IQ-1000 Wiring Changes

June 1990

INPUT WIRING FOR 240 VAC CONTROL POWER

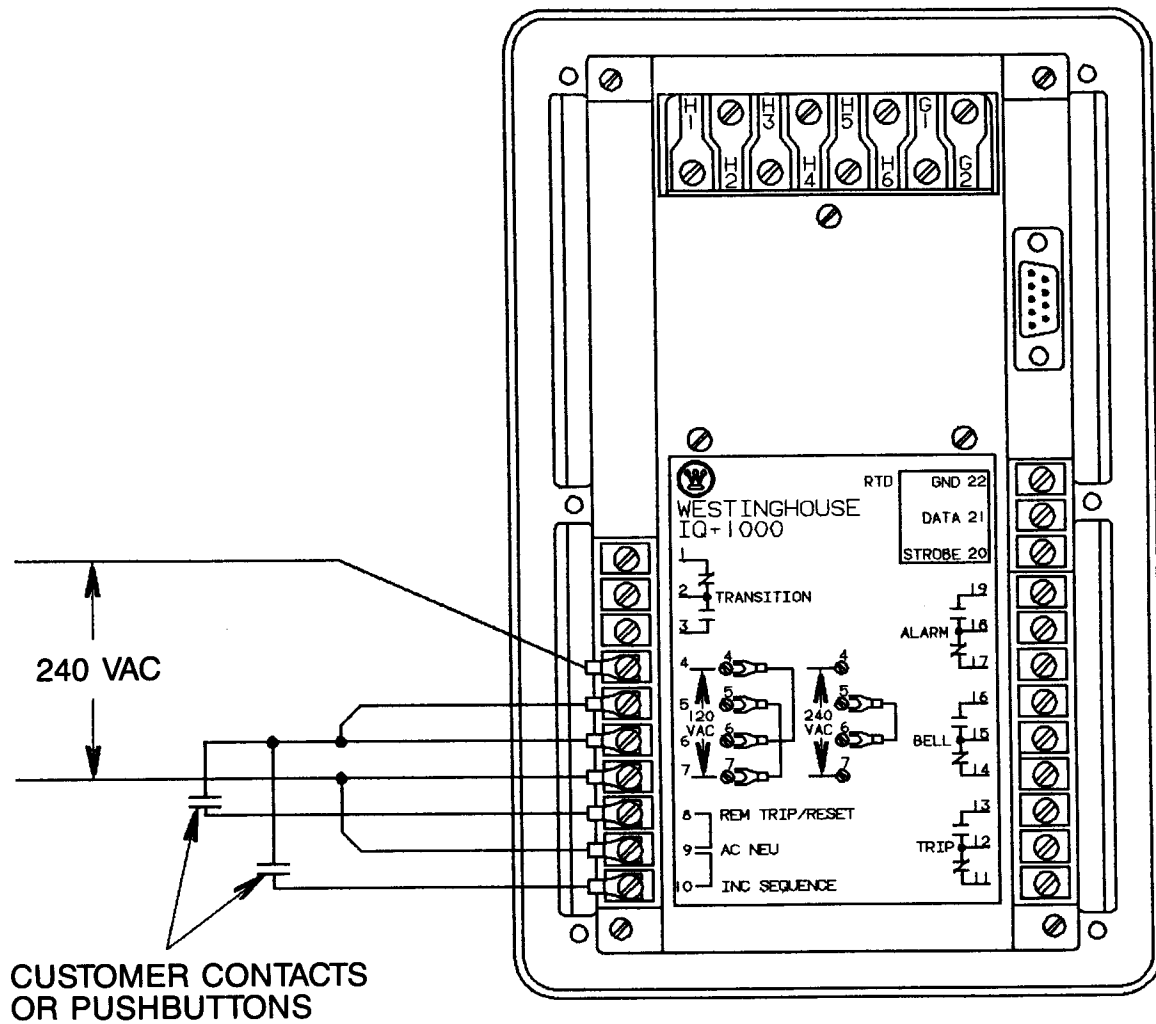
An error has been brought to my attention in the IQ-1000 manual regarding the wiring connections to disable the Incomplete Sequence feature. This error is located on page 19 of technical manual TD 17194 and only affects users with 240 VAC applications.

On page 19, in the first "NOTE" box, the manual indicates the incorrect jumper wiring to disable the Incomplete Sequence for 240 VAC operation. Damage to the IQ-1000 may result if the jumpers are wired according to page 19. For the correct wiring connections, jumpers should be installed between terminals 6 and 10 and between terminals 5 and 7. This wiring configuration is shown correctly in the figure on page 61 of the technical manual. A wiring diagram has also been included with this letter.
